**Statement of Response to An Bord Pleanála's Opinion  
in relation to Reg. Ref.: ABP- 312202-21**

**A Proposed Strategic Housing Development**

**North west corner of Omni Park  
Shopping Centre, Santry Hall Industrial Estate, Swords  
Road, Dublin 9**

**John Spain Associates**

**Figure 2.1: overview of permeability and open spaces within the proposed development and to Omni Park. (source: JFA, 2022)**

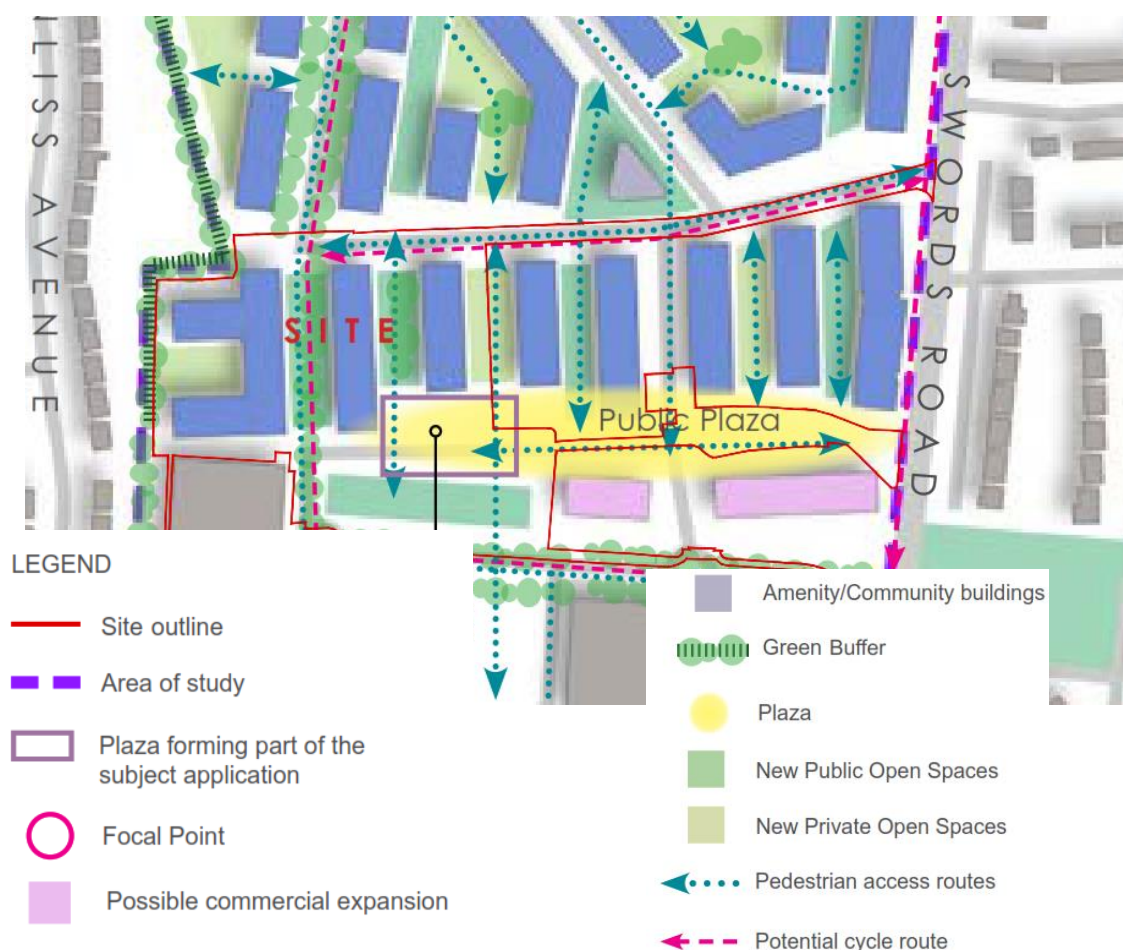
*(a) sufficient permeability from the site through the Omni Park to provide appropriate linkages to the Swords Road for pedestrians/cyclists,.*

- In response to this the landscape design has been amended to include the Swords Road entry plaza, previously approved as part of the Omni Living SHD, within our proposed scheme.

- As well as this the southern pedestrian link will be improved and northern pedestrian link widened to allow shared pedestrian and cycle paths to both routes. We believe these combined approaches provides a robust connection from Santry Avenue through the District Centre into the proposed Omni Plaza development.

2.7. The site has been laid out with pedestrian movement as a priority, with car movements eliminated from within the site area as far as possible through the provision of a basement car park. A new landscaped pedestrian spine will link the proposed public plaza and the entrance plaza of Omni Living, creating a safe and legible route for pedestrians from Swords Road to the scheme. In addition an upgraded pedestrian & cycle link will be provided to the south.

**Figure 2.3: proposed massing / height in context of framework strategy within JFA Design Statement. (Source: JFA, 2022)**

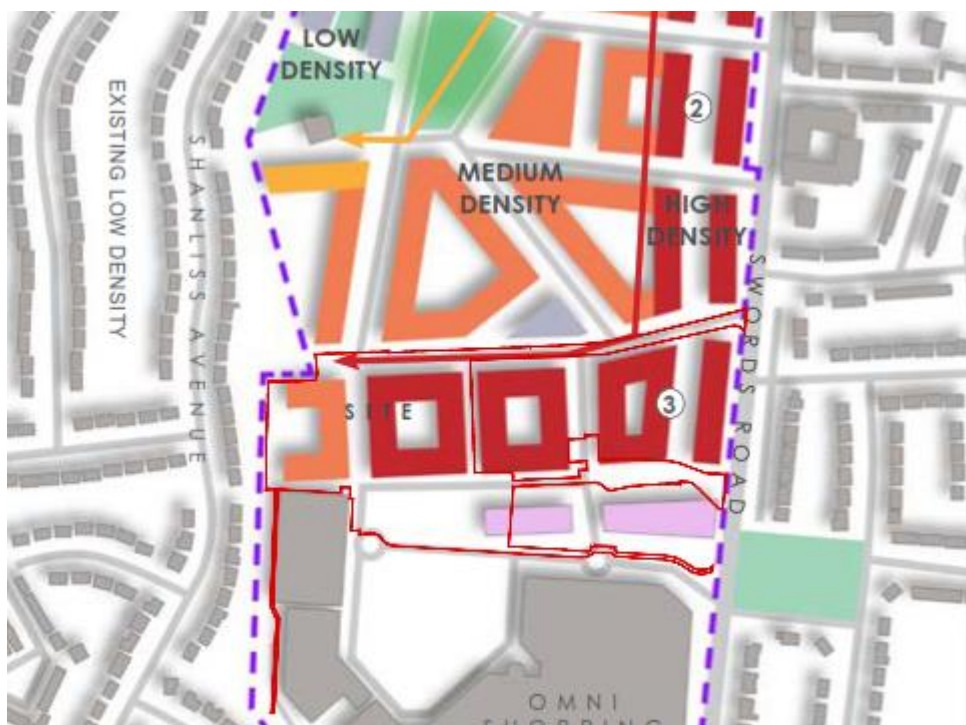
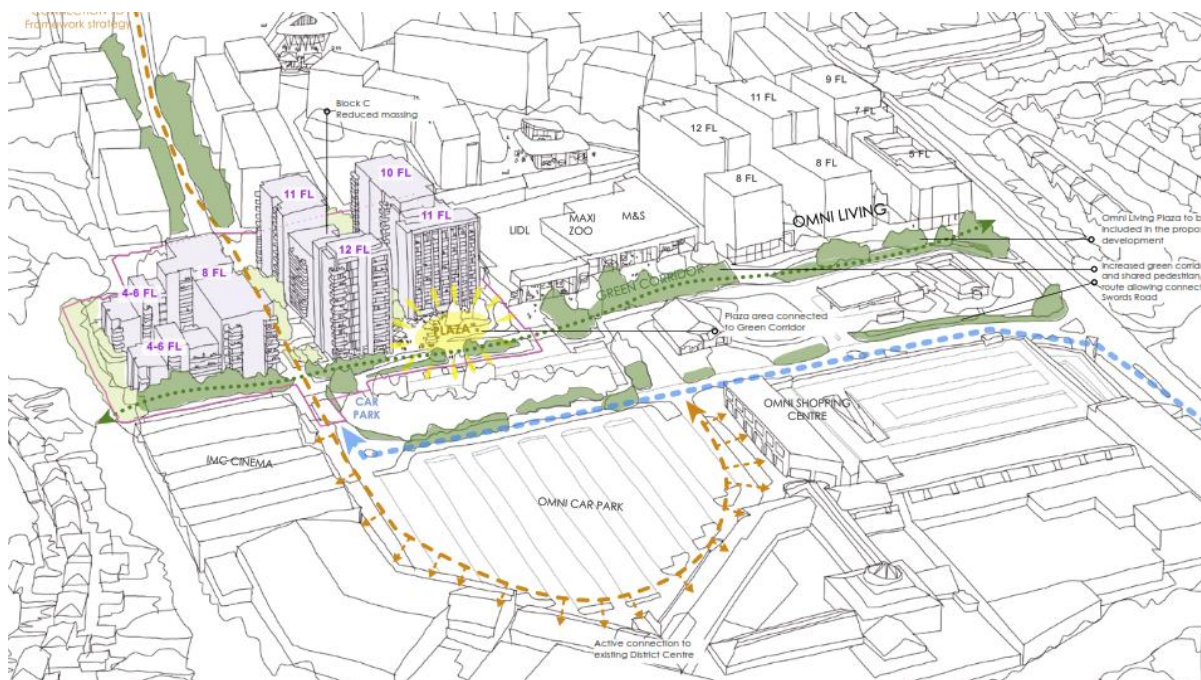
*(b) the design rationale for the proposed design, scale and mass of the buildings within the Omni Park to ensure an attractive high-quality residential environment is achieved. Particular regard should be had 12 criteria set out in the Urban Design Manual which accompanies the Guidelines for Planning Authorities on Sustainable Residential Development in Urban Areas (May 2009) and the requirement for good design and the inclusion of a sense of place*

- 2.13. As set out in the diagrams above prepared by JFA the as part of the Framework Strategy prepared. The proposed development specifically density has been design in accordance with the permitted and potential surrounding context. The height, massing and density of the proposed development have been carefully developed in response to the permitted and existing context balancing the existing residential amenity and noting the significant potential for change in the area. Santry Place has completed 3 blocks of the residential components. An application for an additional 7 storey mixed-use office / residential block development to the west of the site has recently been made to DCC and is under consideration (DCC Reg. Ref. 4549/22).

*The proposal has varied its massing, concentrating the taller element away from the existing low density residential dwellings to the west, yet providing for a strong urban edge and active frontage to Omni Park.*

**Figure 2.5: selection of finishes and materials chosen. (Source: JFA, 2022).**

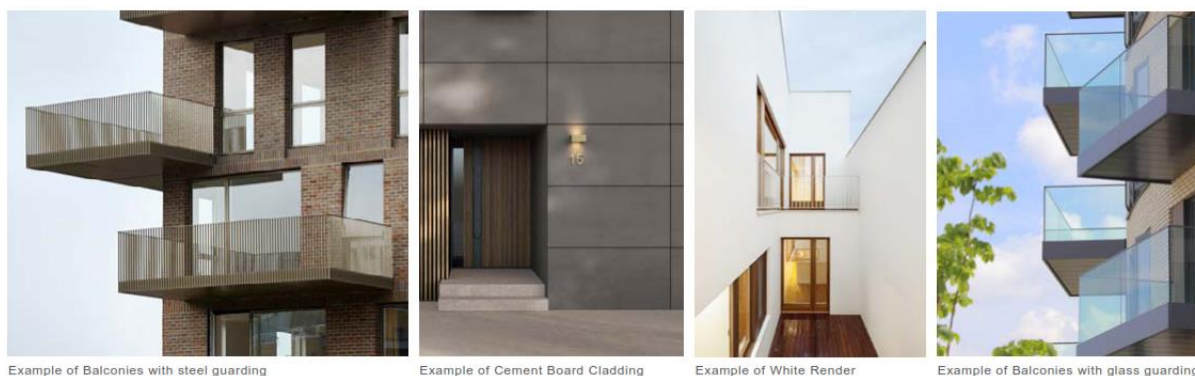
*1. A report that specifically addresses the proposed materials and finishes to the scheme including specific detailing of finishes, the treatment of balconies in the apartment buildings, landscaped areas, pathways, entrances, boundary treatment/s and retail/ commercial/ crèche area. Particular regard should be had to the requirement to provide high quality and sustainable finishes and details which seek to create a distinctive character for the development. The documents should also have regard to the long-term management and maintenance of the proposed development and a life cycle report for the apartments in accordance with section 6.3 of the Sustainable Urban Housing: Design Standards for New Apartments (2020).*

*“The selected materials were chosen to sit harmoniously within the Omni District Centre, where recent developments have employed light coloured render and reconstituted stone cladding to create a fresh and bright environment, in a step change from the darker brick that dominated earlier phases of work.*

*The proposed scheme will comprise primarily of high quality buff brick with simple vertical brick detailing at lower levels to engage the gaze. A lighter brick is employed above, again ensuring that there is a sense of texture across the facade.*

**Figure 2.6 overview of approximate timeline illustrating compatibility of proposed development with infrastructure upgrade works. (Source: Serendale Ltd./EirEng, 2022)**

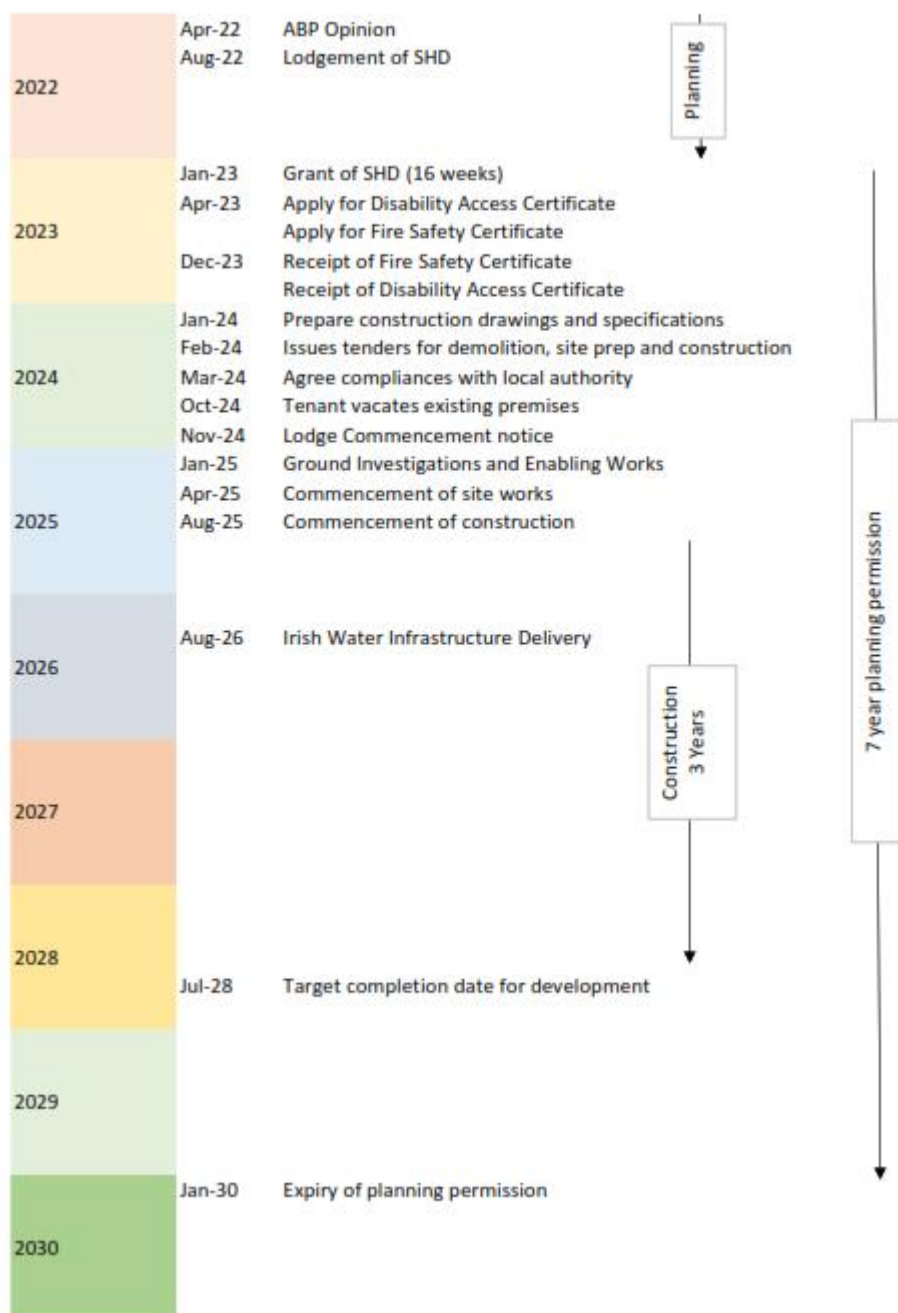
*2. Further consideration and/ or justification of the documents as they relate to the proposed wastewater services. In particular, the consideration/clarification should address the contents of the submission from Irish Water concerning the need to for all works and/or agreements necessary to facilitate the connection and/or upgrade of the development to wastewater infrastructure. Clarity is required at application stage as to what upgrade works are required, who is to deliver these works, when are the works to be delivered relative to the completion of the proposed housing development and whether such upgrade works are to be the subject of separate consent processes.*

- 2.22. Following engagement by EirEng and the Applicant with Irish Water, this required clarification is now provided and the production of a detailed project timeline for the proposed development by the client and design team is enclosed (Figure 2.6 below).

*“The projected completion date for the development, subject to a planning grant, is July 2028 and a minimum 1.5 years later than the projected Irish Water upgrade delivery date, which Irish Water have noted in correspondence as being “currently on track for substantial completion of the works in 2026”. A detailed project timeline for the proposed development is included in Appendix E. The earliest expiry date for a grant of planning pursuant to this development (assuming a decision within 16 weeks) is January 2030. This allows a further buffer beyond the delivery date of the Irish Water upgrade delivery if required. Notwithstanding these dates the client has agreed, and*

*as would be expected to be included in a standard condition wording of any planning decision, that first occupation of any unit will not take place until a connection agreement, and subsequent connection, is in place for the development.”*

**Figure 3.1: extract of JFA OMN-JFA-EL-00-DR-A-P4010 illustrating contiguous southern elevation of the proposed development (Source: JFA, 2022).**

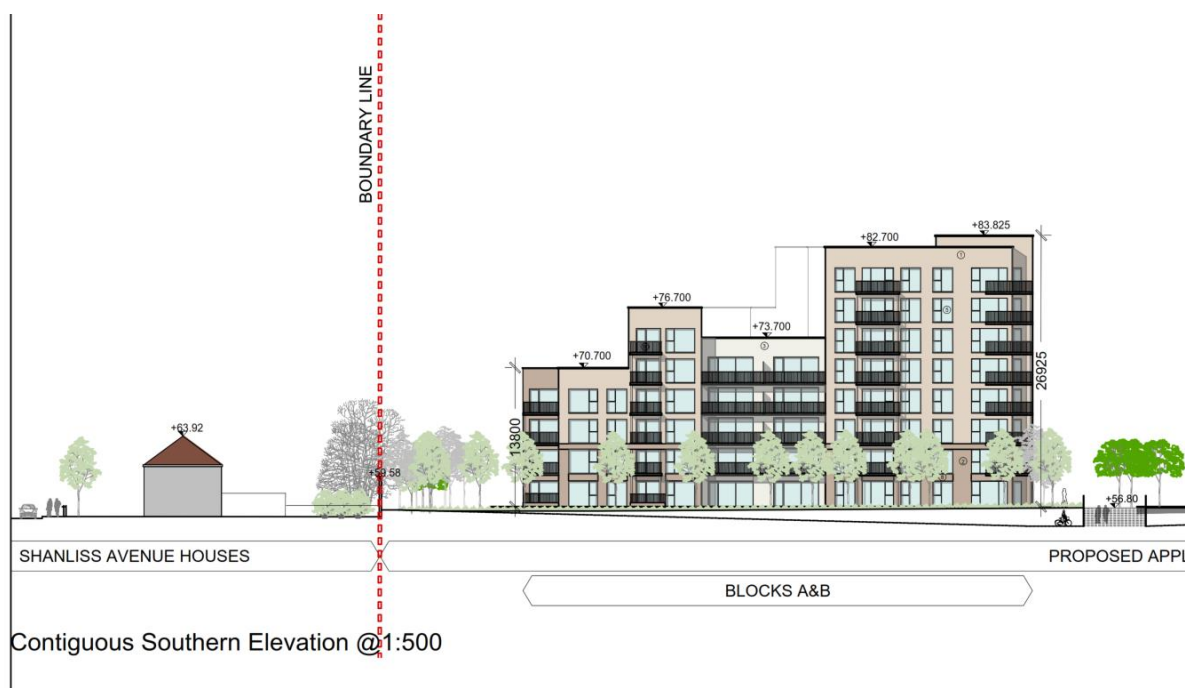
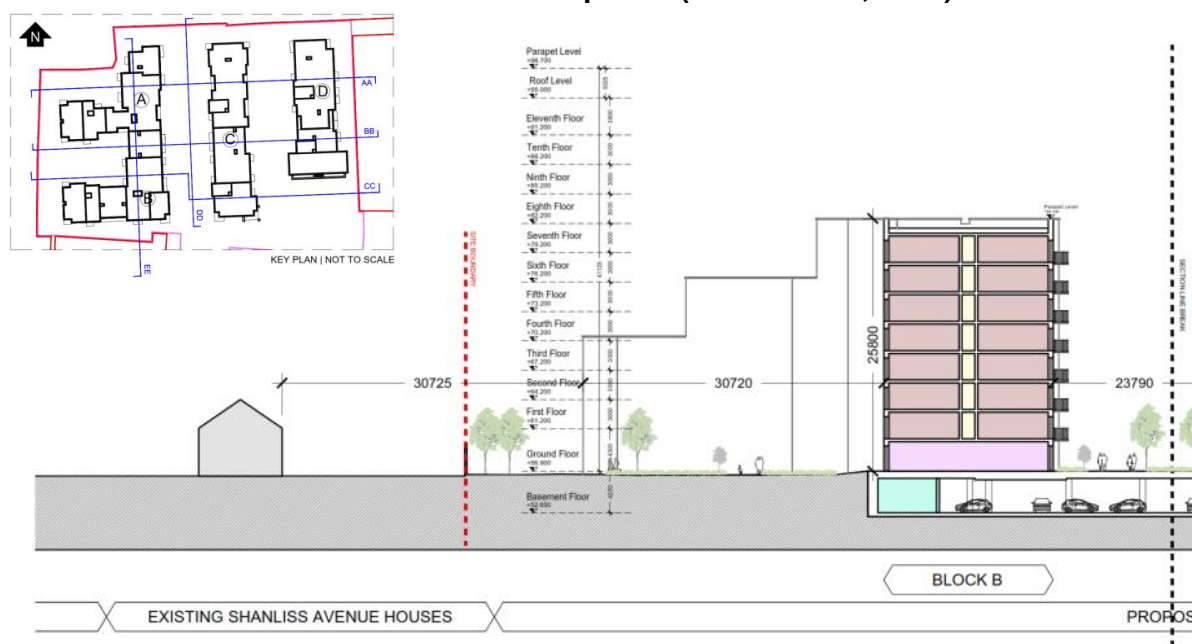
*3. Additional Computer-Generated Images (CGIs) and visualisation/cross section drawings should elaborate on the visual impact of the proposed development in the context of the impact of the residential area to the west of the site.*

- 3.22. The following cross sections have been prepared by JFA to further outline the nature of potential impact on the neighbouring residential areas (OMN-JFA-EL-00-DR-A-P4010).

**Figure 3.3: basis for communal and open space calculations (Source: JFA, 2022).**

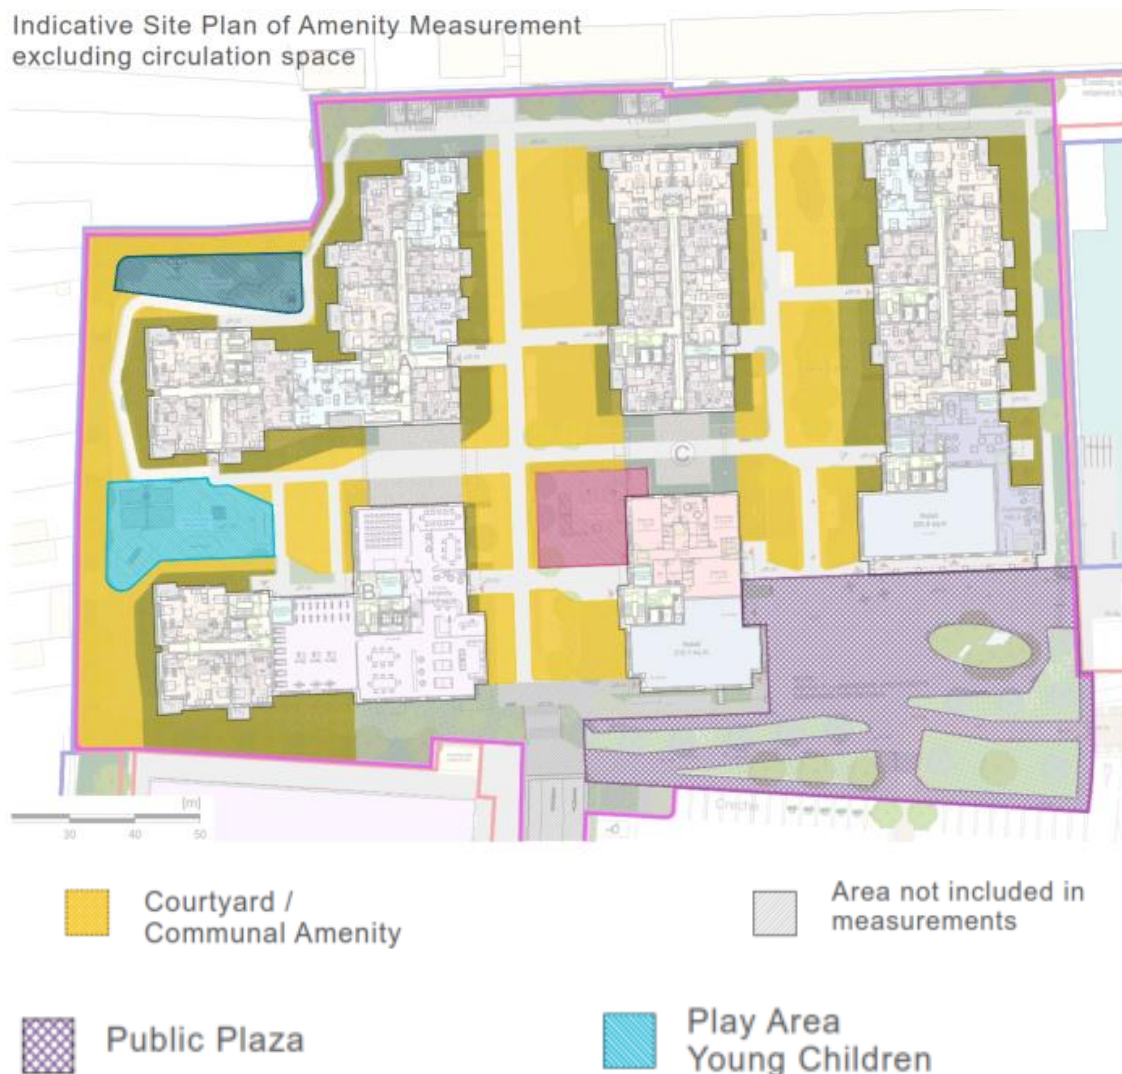
*5. A quantitative and qualitative assessment which provides a breakdown of the communal and public open space. The assessment shall detail the functionality of the public space and shall disregard any areas required for circulation space such as footpaths between buildings etc.*

- 3.41. In response to this item Figure 3.3 below sets out the basis for open space calculation. For further detail on the usability of these spaces please see landscape drawings and Design Statement prepared by Murray and Associates.
